STATEMENT OF DEFICIENCIES AND PLAN OF CORRECTION		(X1) PROVIDER/SUPPLIER/CLIA IDENTIFICATION NUMBER: 205138	(X2) MULTIPLE CONSTRUCTION A. BUILDING 01 B. WING _____		RECEIVED SEP 07 2023	(X3) DATE SURVEY COMPLETED 08/29/2023
NAME OF PROVIDER OR SUPPLIER LAKEWOOD A CONTINUING CARE CENTER			STREET ADDRESS, CITY, STATE, ZIP CODE 220 KENNEDY MEMORIAL DR WATERVILLE, ME 04901			
(X4) ID PREFIX TAG	SUMMARY STATEMENT OF DEFICIENCIES (EACH DEFICIENCY MUST BE PRECEDED BY FULL REGULATORY OR LSC IDENTIFYING INFORMATION)	ID PREFIX TAG	PROVIDER'S PLAN OF CORRECTION (EACH CORRECTIVE ACTION SHOULD BE CROSS-REFERENCED TO THE APPROPRIATE DEFICIENCY)		(X5) COMPLETION DATE	
E 000	Initial Comments Federal Recertification survey Date: 8/29/2023 Lakewood A Continuing Care, a long term care facility, is in substantial compliance with 42 Code of Federal Regulations Part 483.73- Emergency Preparedness Requirement for Long Term Care Facilities.	E 000

NAME OF PROVIDER OR SUPPLIER LAKEWOOD A CONTINUING CARE CENTER	STREET ADDRESS, CITY, STATE, ZIP CODE 220 KENNEDY MEMORIAL DR WATERVILLE, ME 04901
---	--

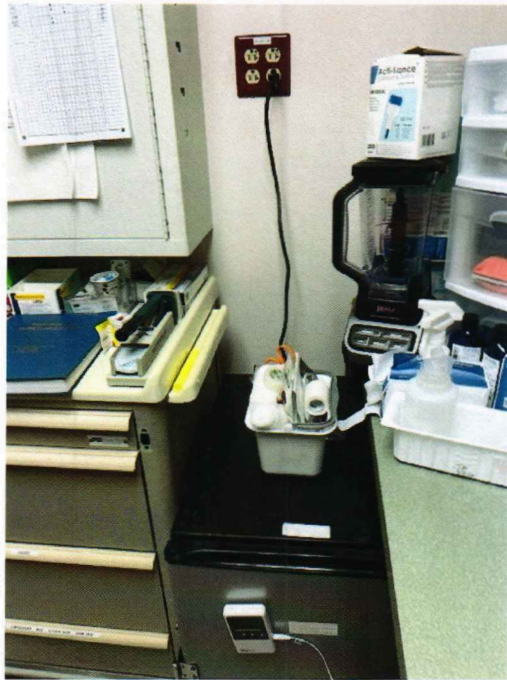
STATEMENT OF DEFICIENCIES AND PLAN OF CORRECTION		(X1) PROVIDER/SUPPLIER/CLIA IDENTIFICATION NUMBER: 205138	(X2) MULTIPLE CONSTRUCTION A. BUILDING 01 B. WING _____		RECEIVED SEP 07 2023	(X3) DATE SURVEY COMPLETED 08/29/2023
NAME OF PROVIDER OR SUPPLIER LAKEWOOD A CONTINUING CARE CENTER			STREET ADDRESS, CITY, STATE, ZIP CODE 220 KENNEDY MEMORIAL DR WATERVILLE, ME 04801			
(X4) ID PREFIX TAG	SUMMARY STATEMENT OF DEFICIENCIES (EACH DEFICIENCY MUST BE PRECEDED BY FULL REGULATORY OR LSC IDENTIFYING INFORMATION)	ID PREFIX TAG	PROVIDER'S PLAN OF CORRECTION (EACH CORRECTIVE ACTION SHOULD BE CROSS-REFERENCED TO THE APPROPRIATE DEFICIENCY)		(X5) COMPLETION DATE	
K 363	Continued From page 2 and are made of 1 3/4 inch solid-bonded core wood or other material capable of resisting fire for at least 20 minutes. Doors in fully sprinklered smoke compartments are only required to resist the passage of smoke. Corridor doors and doors to rooms containing flammable or combustible materials have positive latching hardware. Roller latches are prohibited by CMS regulation. These requirements do not apply to auxiliary spaces that do not contain flammable or combustible material. Clearance between bottom of door and floor covering is not exceeding 1 inch. Powered doors complying with 7.2.1.9 are permissible if provided with a device capable of keeping the door closed when a force of 5 lbf is applied. There is no impediment to the closing of the doors. Hold open devices that release when the door is pushed or pulled are permitted. Nonrated protective plates of unlimited height are permitted. Dutch doors meeting 19.3.6.3.6 are permitted. Door frames shall be labeled and made of steel or other materials in compliance with 8.3, unless the smoke compartment is sprinklered. Fixed fire window assemblies are allowed per 8.3. In sprinklered compartments there are no restrictions in area or fire resistance of glass or frames in window assemblies. 19.3.6.3, 42 CFR Parts 403, 418, 460, 462, 483, and 485 Show in REMARKS details of doors such as fire protection ratings, automatics closing devices, etc. This REQUIREMENT is not met as evidenced by: Based on observation and interview, the long term care facility failed to maintain the corridor door from positively latching per NFPA 101, Life Safety Code, 2012 Edition, Sections 19.3.6.3.	K 363

STATEMENT OF DEFICIENCIES AND PLAN OF CORRECTION		(X1) PROVIDER/SUPPLIER/CLIA IDENTIFICATION NUMBER: 205138	(X2) MULTIPLE CONSTRUCTION A. BUILDING #1 B. WING _____		RECEIVED SEP 07 2023	(X3) DATE SURVEY COMPLETED 08/29/2023
NAME OF PROVIDER OR SUPPLIER LAKEWOOD A CONTINUING CARE CENTER			STREET ADDRESS, CITY, STATE, ZIP CODE 220 KENNEDY MEMORIAL DR WATERVILLE, ME 04901			
(X4) ID PREFIX TAG	SUMMARY STATEMENT OF DEFICIENCIES (EACH DEFICIENCY MUST BE PRECEDED BY FULL REGULATORY OR LSC IDENTIFYING INFORMATION)	ID PREFIX TAG	PROVIDER'S PLAN OF CORRECTION (EACH CORRECTIVE ACTION SHOULD BE CROSS-REFERENCED TO THE APPROPRIATE DEFICIENCY)			(X6) COMPLETION DATE
K 363	Continued From page 3 Findings: On August 29, 2023, between 9:00 am and 12:00 pm, in the accompany of Facility Administrator and the Administrator Director, did observe the following: 1. Two of the 2 hr fire doors in the corridors have upper and lower latching devices that are not positively latching . The findings were confirmed with the Facility Administrator and the Administrator Director at the time of the observation.	K 363	Northern Light Continuing Care Lakewood has contracted with the Door Division of National Firestopping Solutions for repair of the two 2-hr fired doors identified in the survey. Evaluation and estimate of repair was completed on 9/6/23. 2-hr fired doors will be routinely inspected by Director of Facilities, and the Door Division of National Firestopping Solutions, as needed. Date of Completion: October 10, 2023
